Access Compliance Report

Public Rights-of-Way

(Curb Ramps)

Intersection ID: 46789	Main Street: STOWE_ACRES_DR	Cross Street: WILTON_GATE_DR	Location: NE
ADA ID: 3E2B17EFFF31	Ramp Type: PerpDiag	Initial Pass/Fail: Fail	Overall Compliance: No
Severity Score: 22.5			
Codes/Mitigation Info/Possible Solution		Field Measurements/Component Compliance

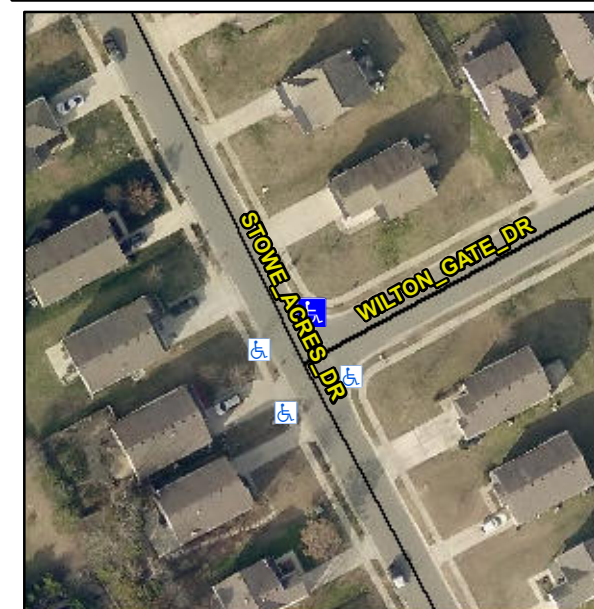
R304.5.1, R304.2.2, R304.5.3

Compliance	Description	Data	Compliance	Description	Data
N/A	Ramp Length (in)	48.5	No	Ramp Slope (%)	9.3
No	Ramp Width (in)	39.0	No	Ramp XSlope (%)	3.2
N/A	Flare Type LT	N/A	N/A	Flare Type RT	N/A
N/A	Flare Slope LT (%)	N/A	N/A	Flare Slope RT (%)	N/A
N/A	Flare Traversable LT?	N/A	N/A	Flare Traversable RT?	N/A
N/A	Landing Length (in)	N/A	N/A	DWS Provided?	N/A
N/A	Landing Width (in)	N/A	N/A	DWS Contrast?	N/A
N/A	Landing Slope (%)	N/A	N/A	DWS Length (in)	N/A
N/A	Landing X Slope (%)	N/A	N/A	DWS Full Width?	N/A
N/A	Landing Curb? (Y/N)	N/A	N/A	DWS Offset (in)	N/A
N/A	Shared Landing?	N/A			
N/A	Gutter Ponding?	N/A	N/A	Gutter Slope (%)	N/A
N/A	Gutter Lip Ht (in)	N/A	N/A	Gutter X Slope (%)	N/A
N/A	Painted X Walk1?	No	N/A	Painted X Walk2?	No
	X Walk 1 Direction	To W		X Walk 2 Direction	To S
N/A	X Walk 1 Width (in)	N/A	N/A	X Walk 2 Width (in)	N/A
	X Walk 1 Slope (%)	0.8		X Walk 2 Slope (%)	0.1
	X Walk 1 X Slope (%)	0.7		X Walk 2 X Slope (%)	1.1

Remove & Replace Curb Ramp With Two New Directional Ramps or Equivalent.
